## **Service Bulletins**

**Rolls-Royce Silver Cloud II**  
**Rolls-Royce Silver Cloud III**  
**Bentley S2**  
**Bentley S3**  
**Phantom V**

SERVICE INFORMATION FOR THE ROLLS-ROYCE SILVER CLOUD III  
AND BENTLEY S. 3.

Figure 1 - Vacuum valve assembly

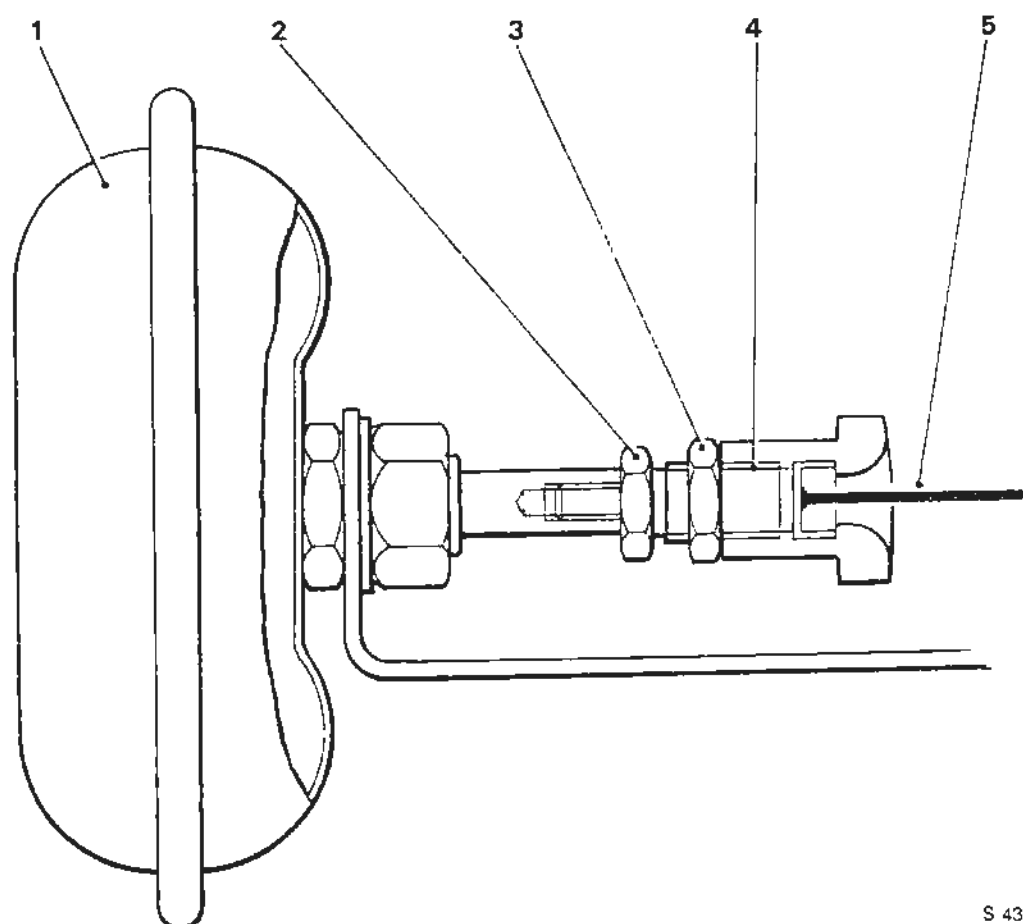
The existing vacuum valve unit is no longer available. Future replacements are a different type which require additional parts.

A screwed adapter (RH 9098) is fitted to the existing push rod on the vacuum valve unit. A new cable and nipple (RH 9100) is fitted, this being attached by means of a retainer (RH 9099) and retaining lock-nut (RE 22430). These are screwed and locked to the adapter (refer, Fig. 1).

FIG 1 EARLIER ASSEMBLY

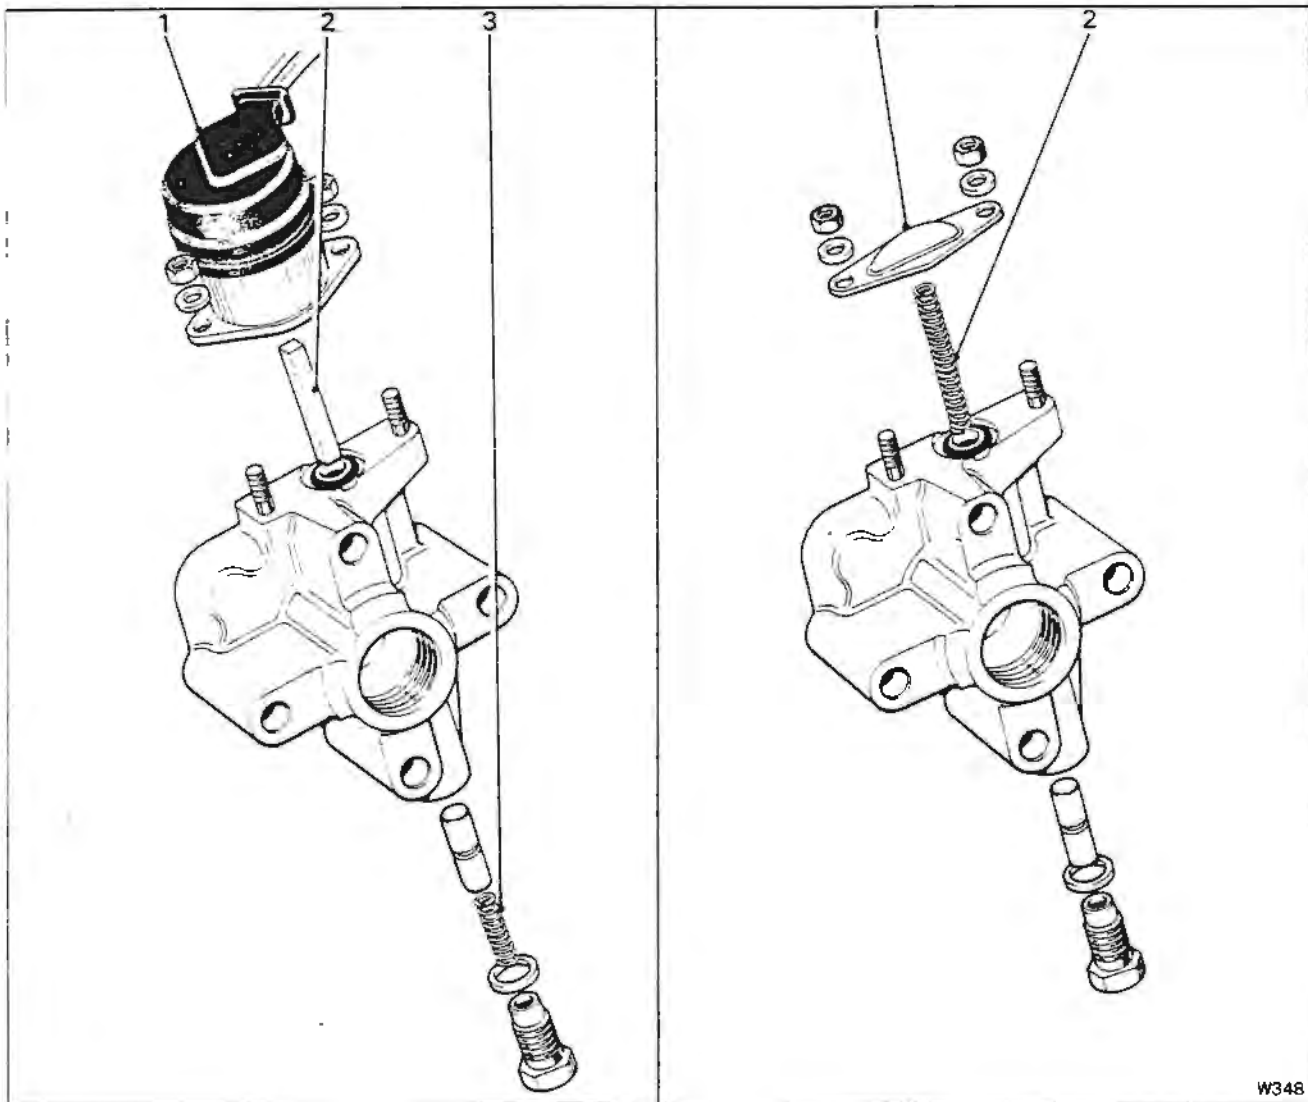
- 3     Disconnect both the wires to each rear damper solenoid and tape them back into the loom.
- 4     Remove the ride control solenoid (see Fig.1)
- 5     Remove the solenoid spring (see Fig.1)
- 6     Remove the slow leak push rod (see Fig.1)
- 7     Fit the new spring in place of the slow leak push rod (see Fig.2)
- 8     Fit the blanking plate in place of the solenoid (see Fig.2)

Fig.1. Dimensions for cutting slots in petrol tank.

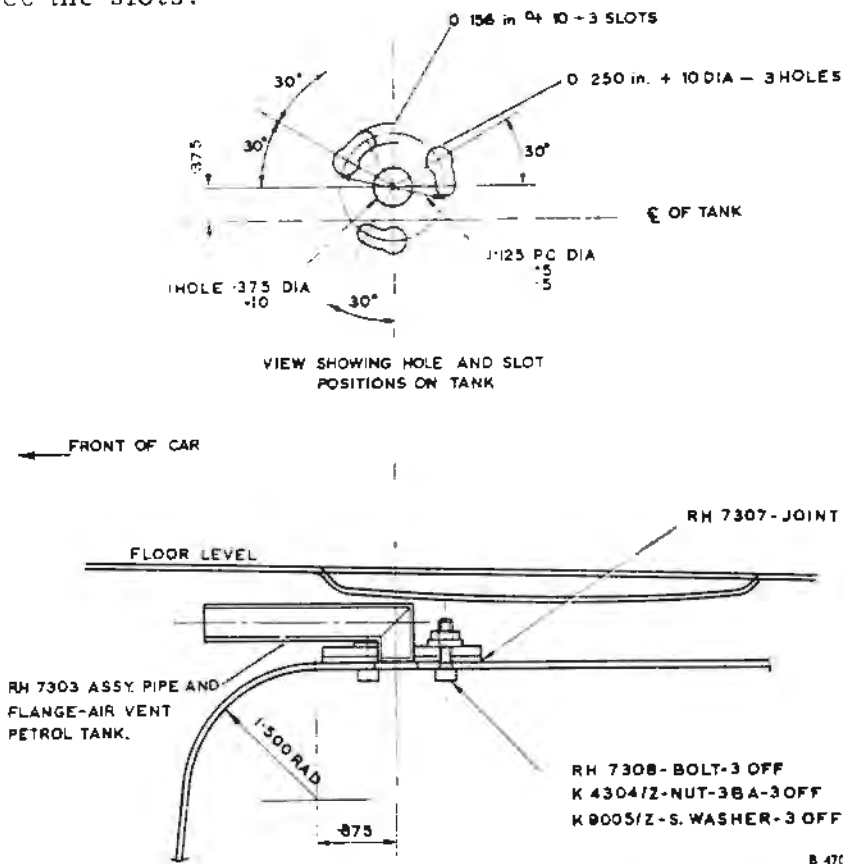
Working to the dimensions given in Figure 1, drill a hole 0.375 in. diameter in the top of the tank, then drill three further holes 0.250 in. diameter and produce the slots.

Fig.2. Dimensions for fitting vent pipe to filler tube.

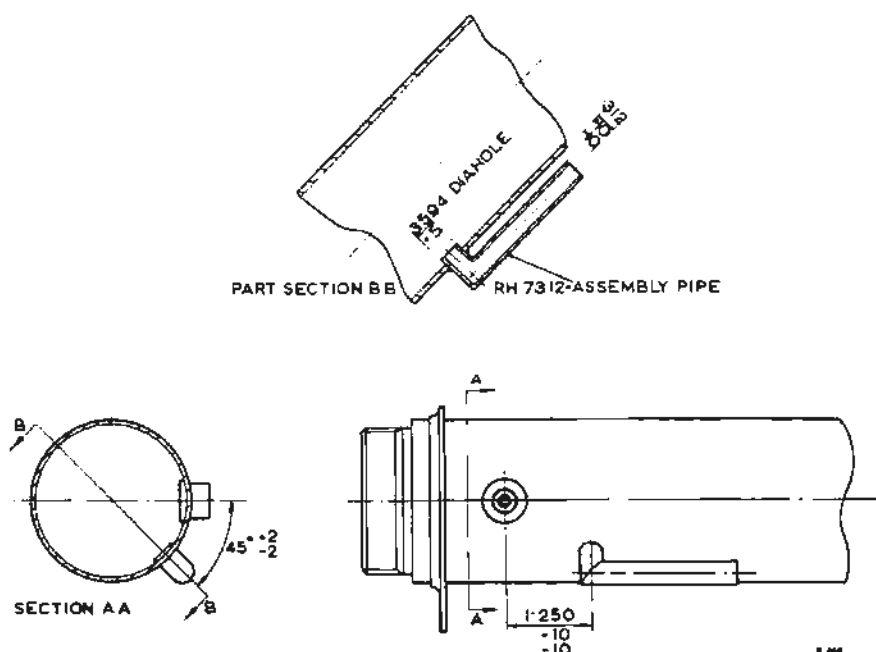
Working to the dimensions given in Figure 2, drill a hole 0.359 in. diameter in the filler tube. Remove all burrs and sharp edges.

Locate the vent pipe (RH.7312) in the hole and 'low temperature braze' it into the filler tube.

Fig.3. Dimensions for drilling grommet hole in boot floor.

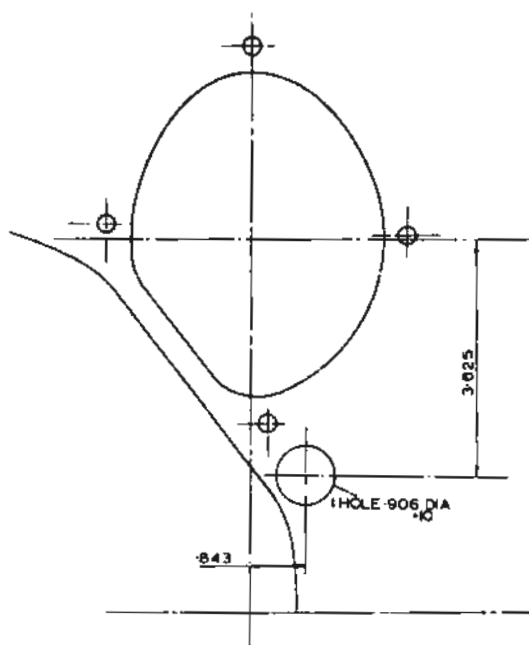
Working to the dimensions shown in Figure 3, drill a hole 0.906 in. diameter in the luggage boot floor. Remove all sharp edges and burrs.

Fig.4. Positioning of rubber hose on filler tube vent pipe.

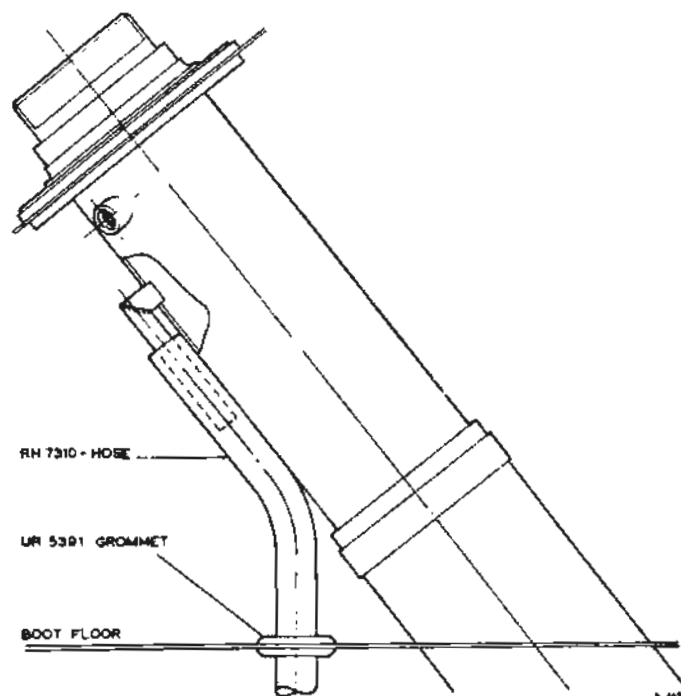
Connect the rubber hose (RH.7310) to the vent pipe in the fuel tank. Pass the other end through the grommet and connect it to the vent pipe in the filler tube as shown in Figure 4.

Fig.1. Method of Modifying the Fuse Holder

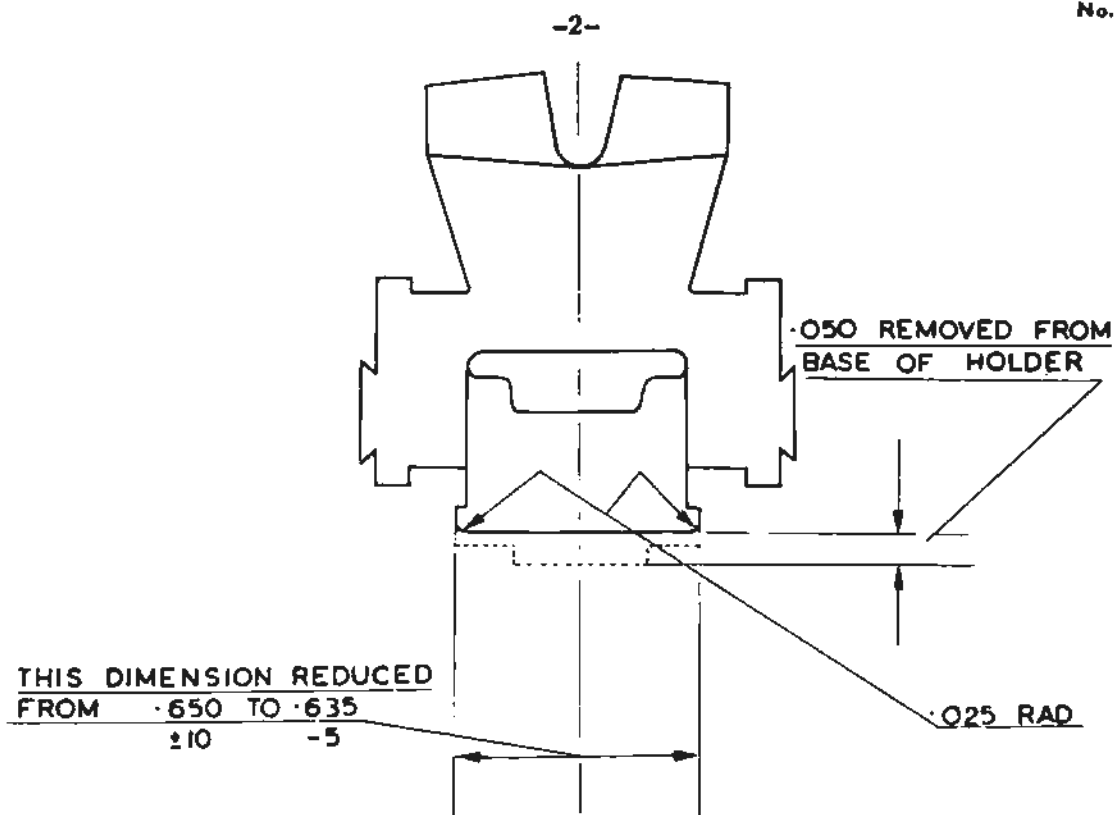
Remove .050 in. from the bottom of the fuse holder and reduce the width of the bottom to between .630 and .635 as shown in Figure 1.

Fig.2. 'A' Correct Method of Fitting the Fuse Wire,  
'B' and 'C' Incorrect Method

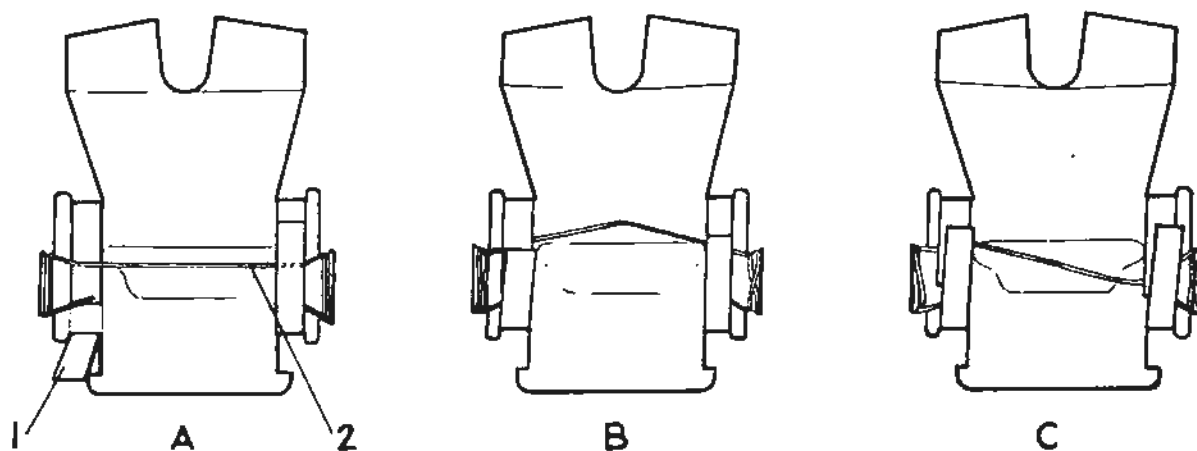
The correct method of fitting the wire is shown, in comparison with incorrect methods, in Figure 2.

Fit the copper strips to the fuse holder so that the fuse wire is firmly trapped and that each end of the copper strip overlaps the wire by an equal amount. The correct method of fitting the fuse wire and the contact strips is shown in 'A' of Figure 2.

Fig.3. 'A' Fuse Clips set Incorrectly.  
'B' Correctly.

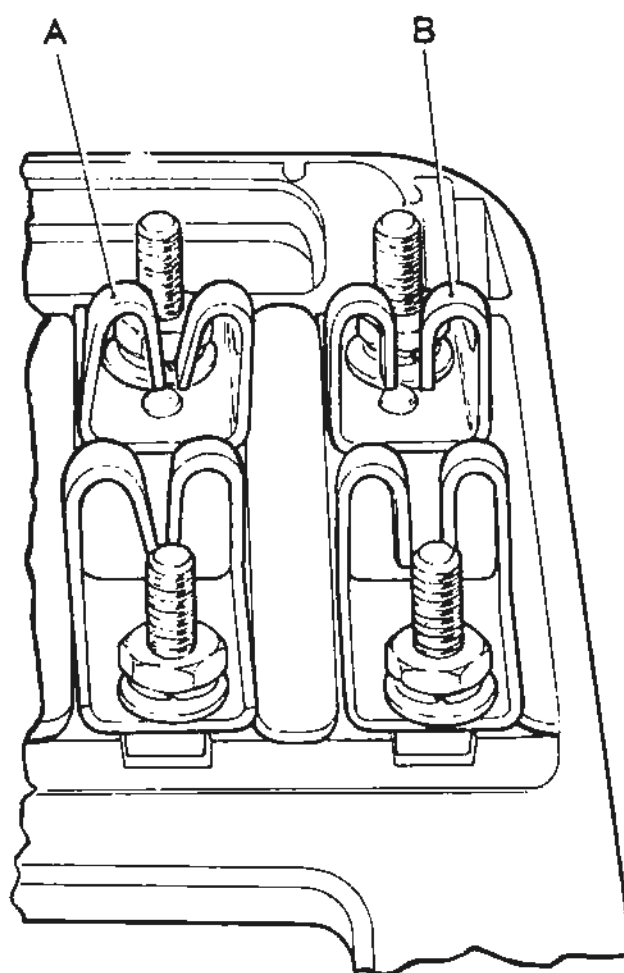
Figure 3 shows a comparison between the fuse clips set correctly and incorrectly.

Figure 1. Direction indicator switch (UR 16530)

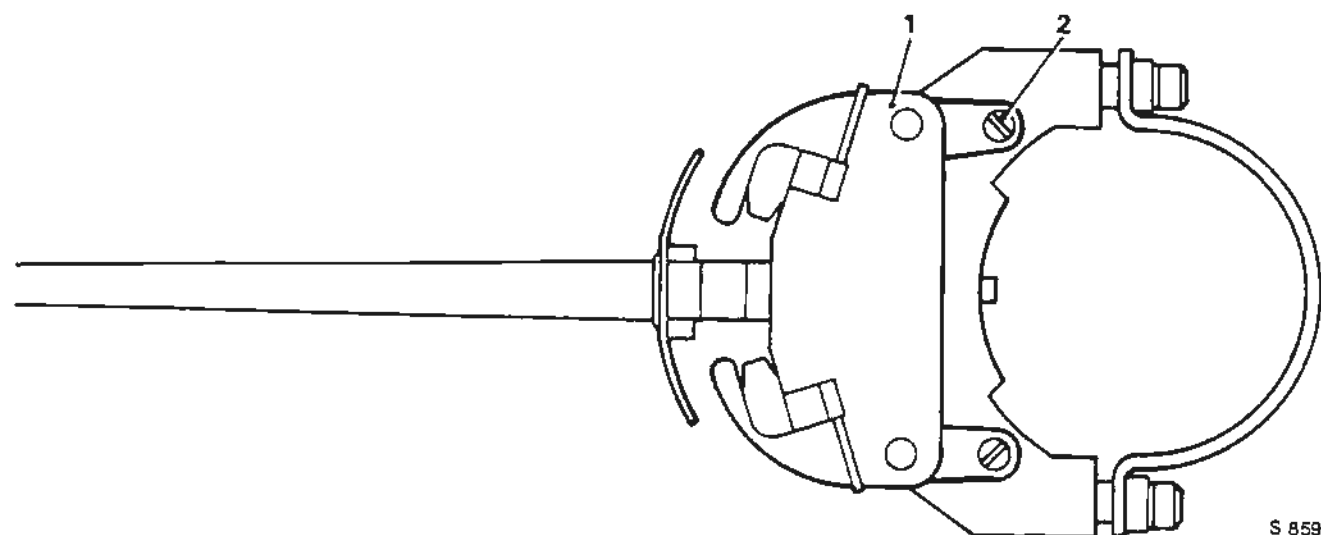
1. The removal and replacement procedure for the new switch remains the same as for the old. However, there is a small modification to be carried out on the new switch as follows:
2. Remove the two screws and discard the brown insulation board (see Fig. 1). Replace the screws with a washer (X 4401) behind each screw head (see Fig 2).
3. Cut the 7 pin plug off and withdraw the insulation board along with the green/yellow and green/blue wires.
4. Fit 'Lucar' connectors to all the wires except the black one to which a bullet connector is fixed. Connect the wires as follows.

Fig.1. Position of Exhaust Pipe Lagging

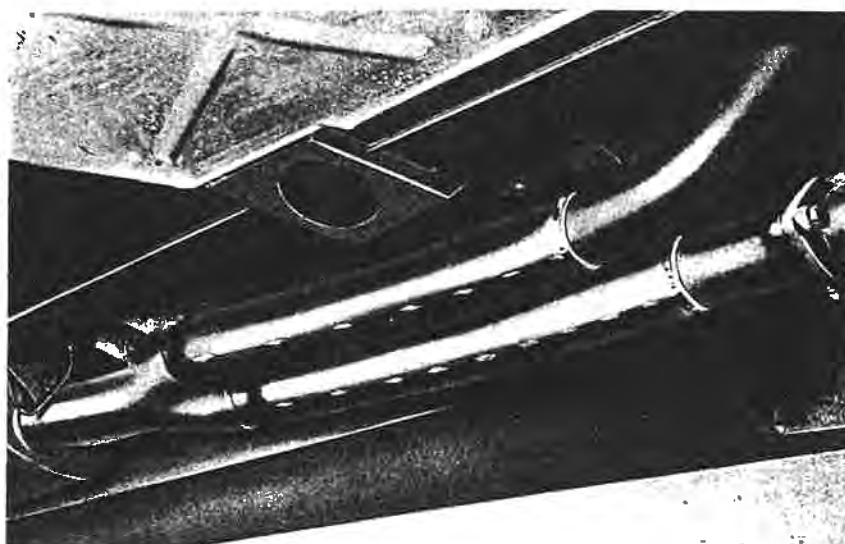
A modification which provides an effective reduction in 'titter', has recently been introduced on production; this modification consists of lagging the two adjacent lengths of exhaust pipes for a distance of approximately twenty inches at a point immediately forward of the breeches piece. (see Fig. 1.)

Fig.1. Dimensions for drilling holes for front seat shackles.

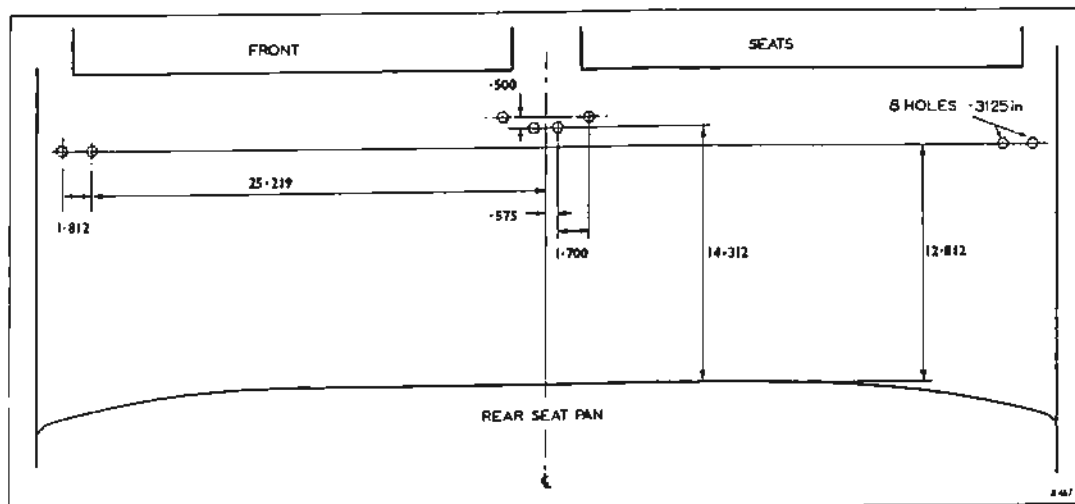
Working to the dimensions given in Figure.1. drill eight 5/16 in. diameter holes in the car floor. The two outer left-hand holes will pass through the exhaust heat shield and care should be taken not to drill through the front silencer box which is positioned directly below the heat shield.

Fig.2. Positions for front seat safety belts and shackles.

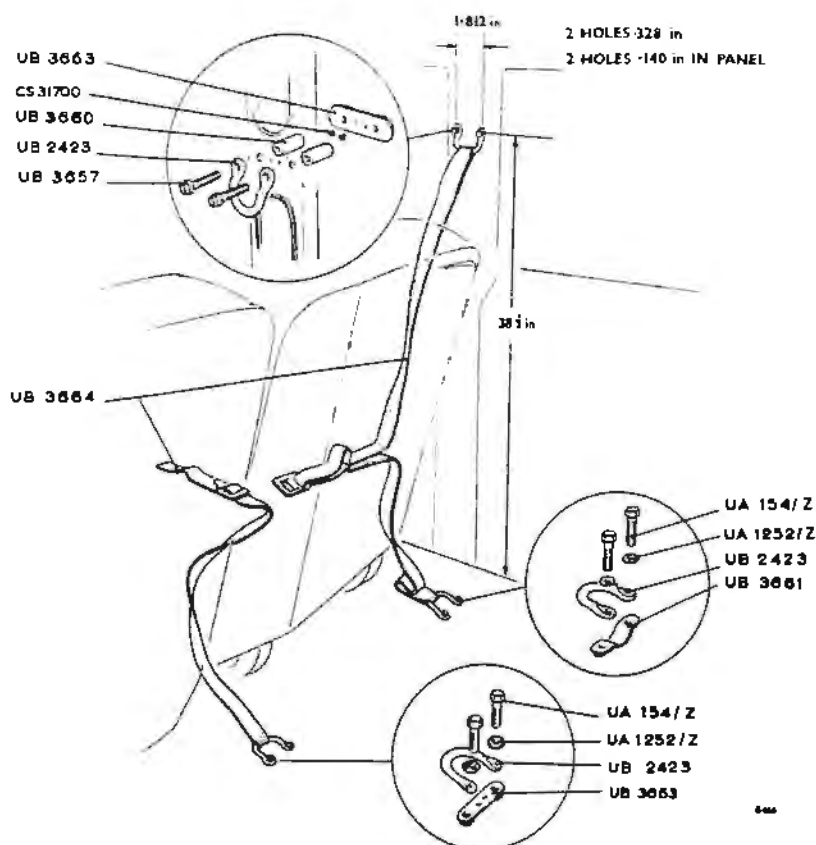
Place a cloth in the centre channel of the door post to prevent swarf dropping inside the channel, then working to the dimensions given in Figure.2. drill two  $21/64$  in. diameter holes in the plate welded to the door post. Drill two further holes,  $9/64$  in. diameter, at  $13/16$  in. centres, and equally spaced to the larger holes, so that they correspond with the holes in the anchor plate (UB.3663). When drilling these holes care should be taken to avoid damage to the wiring looms running inside the door posts.

Fit the six shackles through the loops formed in the belts so that when fitted, the four shackles fitted to the floor will slope forwards and the two shackles fitted to the door posts will slope downwards as shown in Figure.2.

Fig. 3. Dimensions for drilling holes for rear seat 'U' bolts.

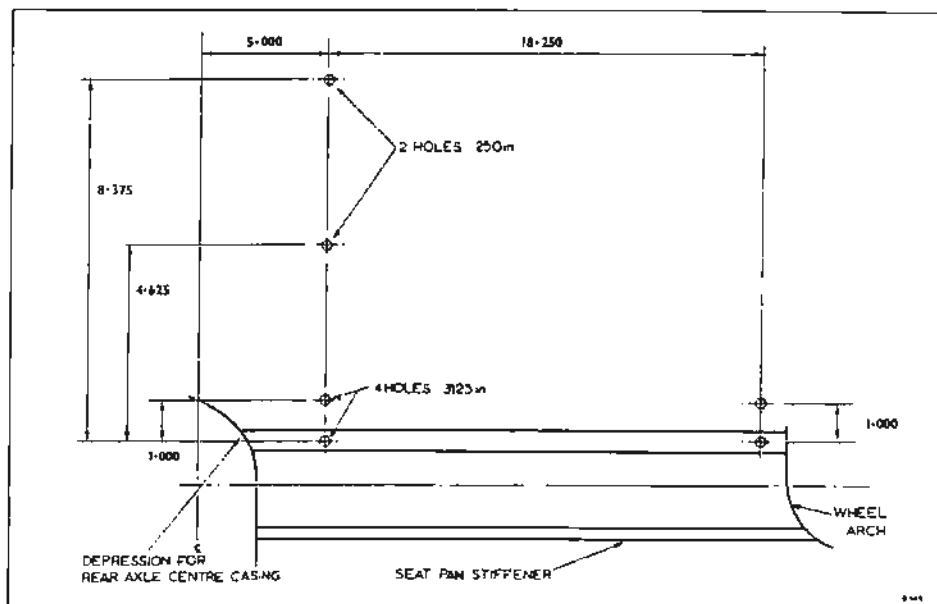
Remove the felt from the seat pan, then working to the dimensions in Figure 3 drill eight 5/16 in. diameter holes and four 1/4 in. diameter holes in the seat pan. The holes drilled slightly to the left of the car centre line will pass through the rear heat shield.

Fig.4. Positions for rear seat Safety belts and 'U' bolts.

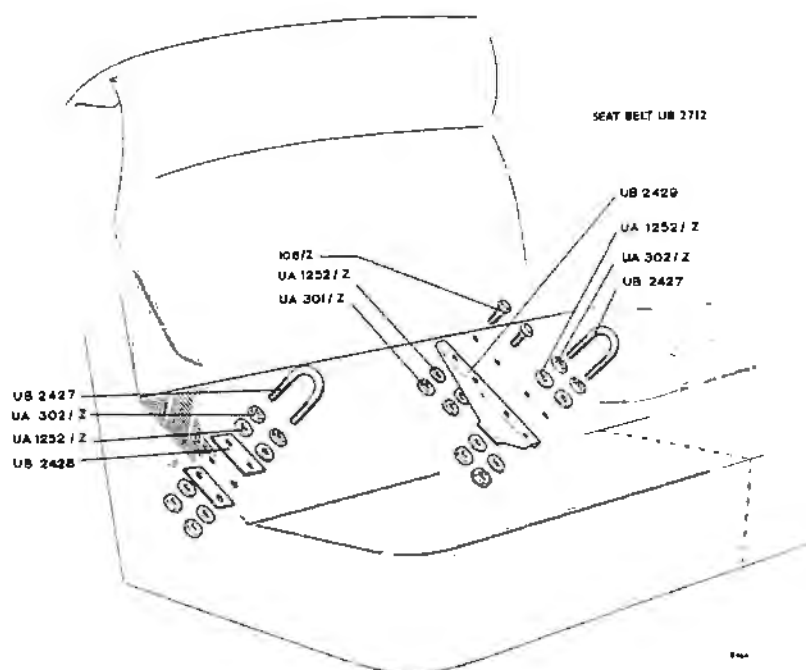
Place the safety belts in the position they will occupy when in use, as shown in Figure 4 then thread the four 'U' bolts through the loops in the belt.

Fit retaining plates (UB.2428) to each of the outer 'U' bolts and then insert them through the appropriate holes in the seat pan. Fit further retaining plates to the 'U' bolts securing them with nuts and washers (see Figure 4). Again ensure that the nuts are tightened both above and below the stiffener plates.
